Product Change Notice (PCN)

PCN Number: PCN-0450092R-01

Product(s) Affected: PJ-003A, PJ-003B, PJ-003AH, PJ-003BH

Old version:

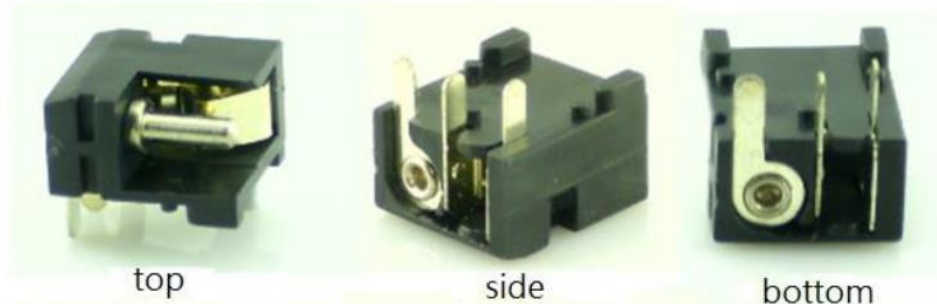
Description of Change: new mold design will adjust the appearance of the products. The electrical structure and function remain the same:
